U.S. Department  
of Transportation  
**Federal Highway  
Administration**

In Reply Refer To: HSSD/B-137D

**Cable Barrier System**  
Patent Pending

SYSTEM: TL-4-4      SCALE: NTS      DRAFTERS: E.J.&T.J      DATE: 10/23/07

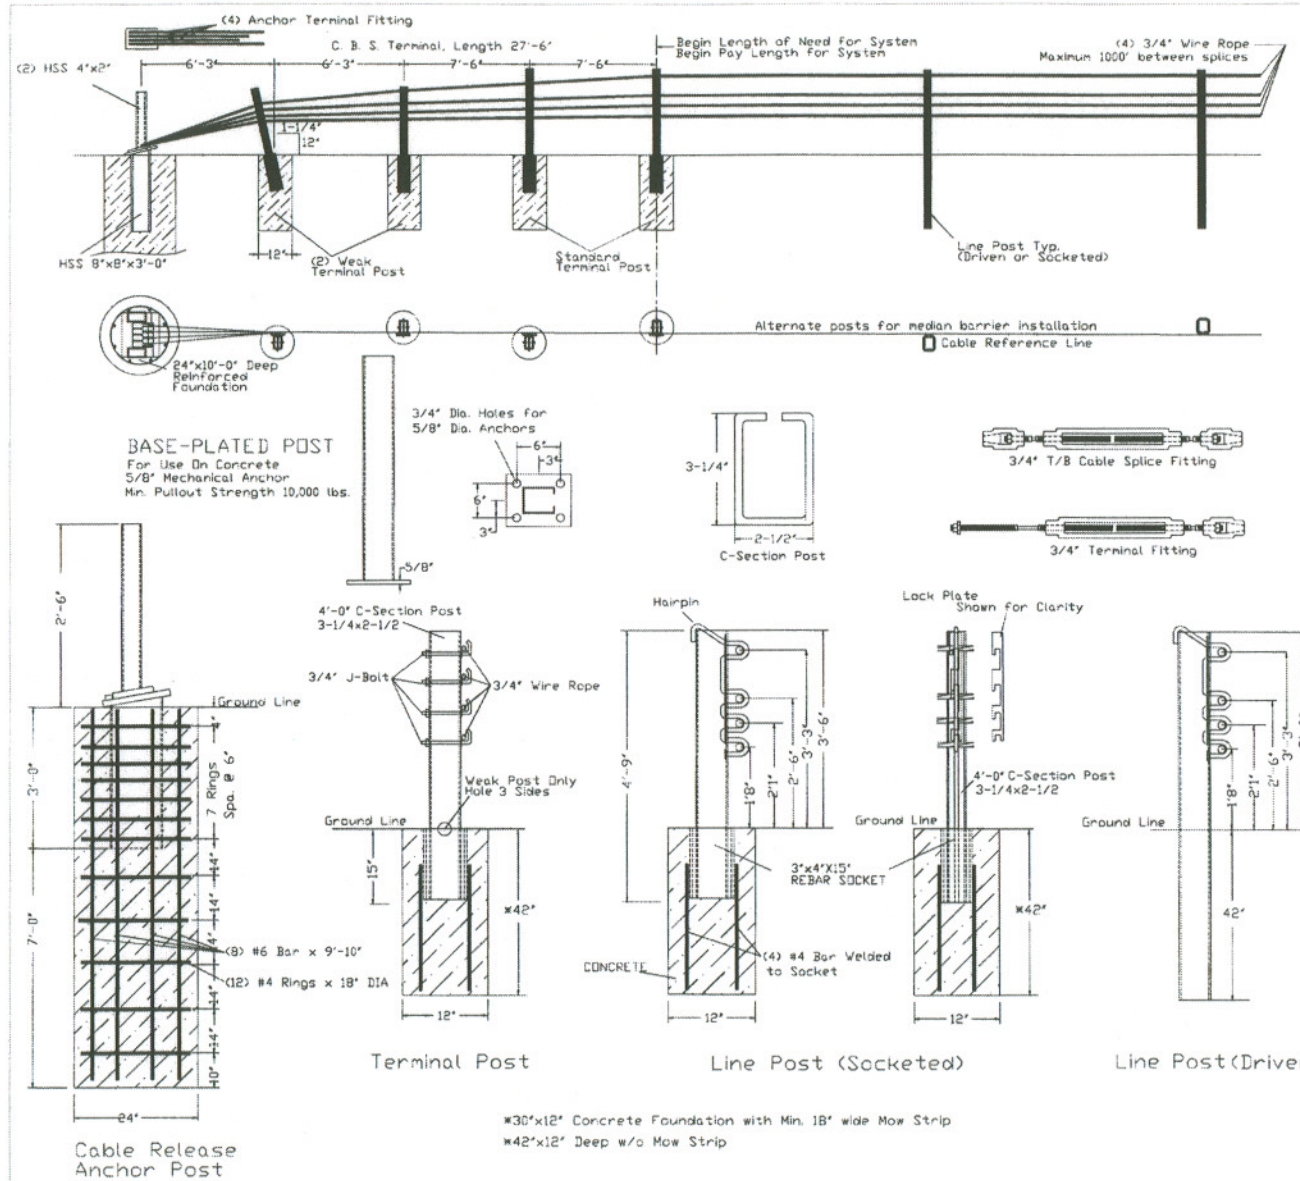
The modified anchor is shown on the enclosed drawings for reference and features the fourth cable attached directly to the anchor post foundation plate instead of being cable clamped to the bottom cable. You also added a fourth J-bolt to each terminal post to accommodate the fourth cable. We concur in this modification and find it acceptable for use with your four-cable barrier.
